PLAN:
Hayek

APPROVED
Limited building only review
Parent holder responsible for full compliance with the code

ELEVATIONS

PROJECT ADDRESS:
TBD Sears Dr. (Lot 27)

A-1

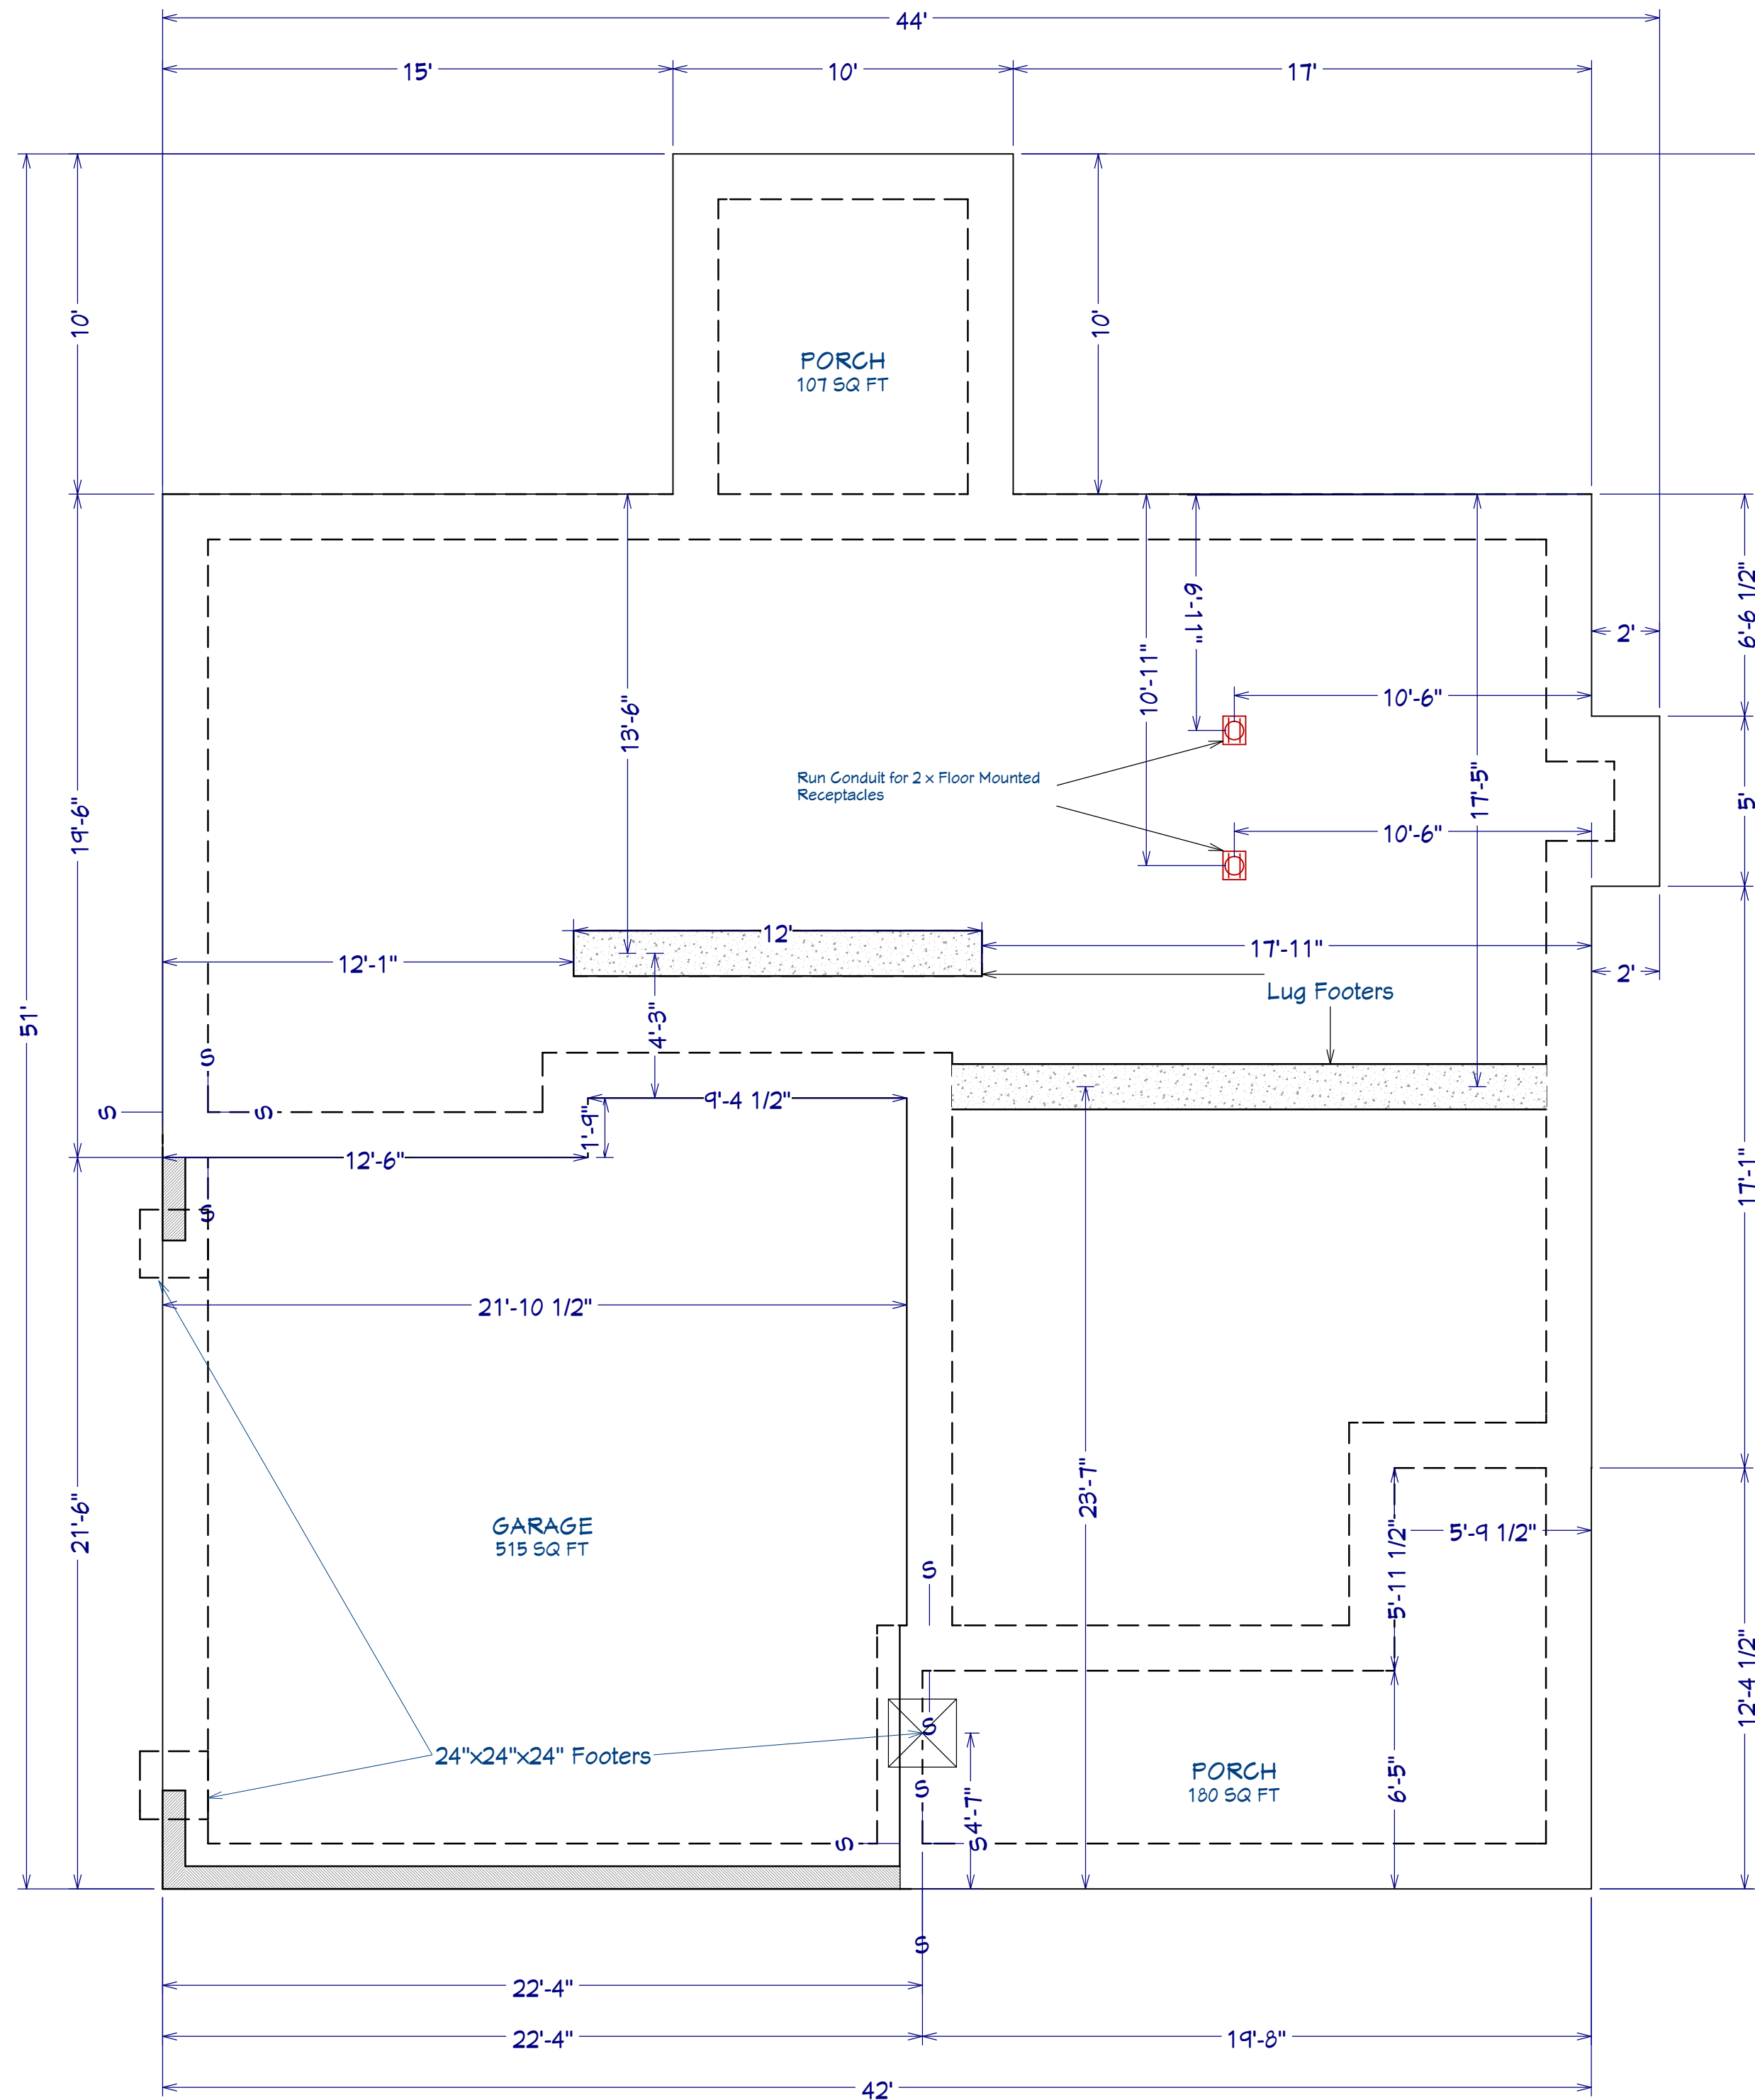
All exterior walls must be 2x6 per energy design
